Service Bulletin

SERVICE PARTS CHANGED FOR IMMOBILIZER UNIT

Bulletin No: 09-001/16

2000-2003 MPV 2001-2005 MX-5

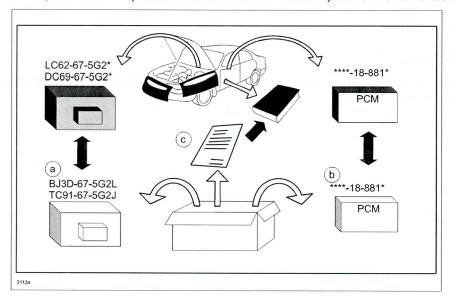
If the immobilizer unit LC62-67-5G2* or DC69-67-5G2* needs to be replaced with a new one, these parts are no longer available. New alternative service parts kits are now available, including alternative immobilizer unit BJ3D-67-5G2L or TC91-67-5G2J. They will require the following additional procedure to be performed in order to work on the vehicle.

- Powertrain Control Module (PCM) has to be replaced with one in the kit.
- The parts kit has to be ordered for the specific VIN due to the necessary PCM replacement.
- · Some vehicles need a wire connection change at the vehicle side connector for the immobilizer unit.

The service parts kit comes with a new immobilizer unit, PCM and related documents.

1. Replace "a" and "b", and insert "c" (DECLARATION of CONFORMITY) into Owner's Manual.

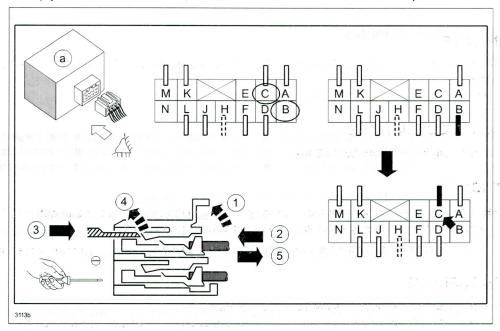
- 2. In order to use this kit, it is necessary to change position of a terminal of the immobilizer unit connector (vehicle harness side) on some vehicles. Check "B" and "C" terminals of the immobilizer unit connector (vehicle harness side).
 - If "B" is empty and "C" has a terminal, it is OK and no terminal position change is necessary.
- If "C" is empty and "B" has a terminal, remove "B" terminal and install it in "C" position.
